Gables Station

COMPREHENSIVE PLAN MAP AMENDMENT
ZONING MAP AMENDMENT
ZONING CODE TEXT AMENDMENT
PLANNED AREA DEVELOPMENT
MIXED USE SITE PLAN

215 AND 251 S. DIXIE HIGHWAY
CITY COMMISSION 2ND READING
JULY 26, 2016

#1: BUILDING HEIGHT

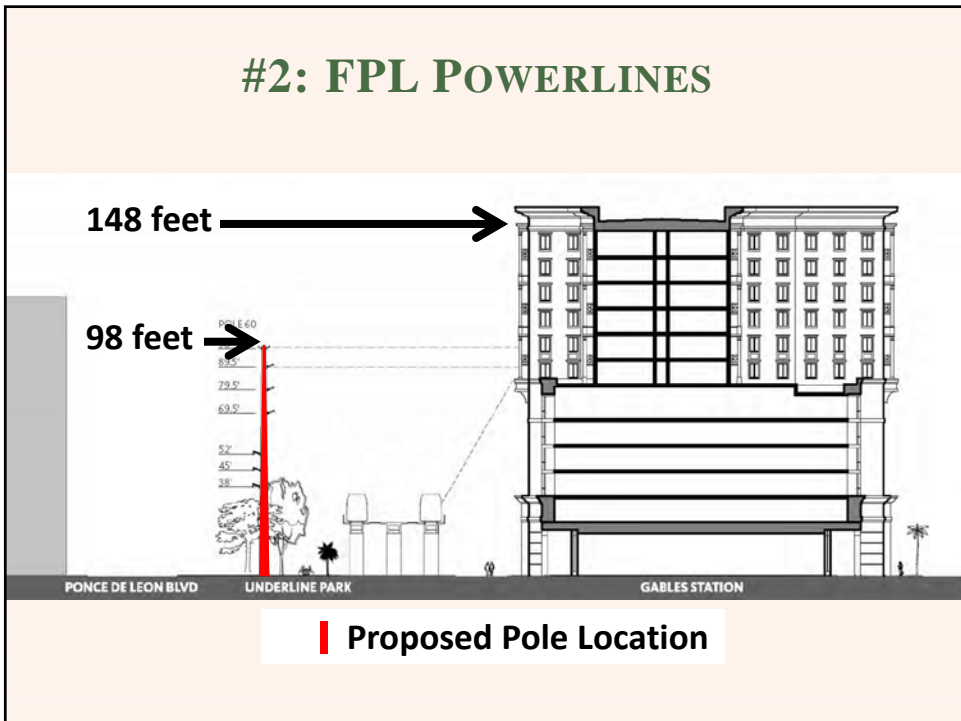
1. Reduce building height while maintaining the same percentage of open space.
2. Show FPL powerline locations in drawings of the Underline.
3. Finalize the trolley contribution proposal.
4. Confirm the timing of the Underline improvements.
5. Update the Traffic Impact Study.
6. Provide the Art in Public Places concept.
7. Update site plan to include more landscaping at the ground level.

The request is justified because the Gables Station project is located on the only site in Coral Gables that:

1. Directly abuts the Metrorail right-of-way, and
2. Is targeted for Mixed-Use redevelopment, and
3. Is of a sufficient size to accommodate a Mixed-Use project.

Therefore, approval of additional height at this site does not create a precedent for other sites along US1.

Due to the specific site characteristics of this Mixed-Use redevelopment site adjacent to Metrorail and its associated noise and visual impacts, **Staff recommends approval of the project at the height proposed by the Applicant: 160 feet for Building A and 148 feet for Buildings B and C.** The proposed height is less than the maximum height allowed in the City (190'6").
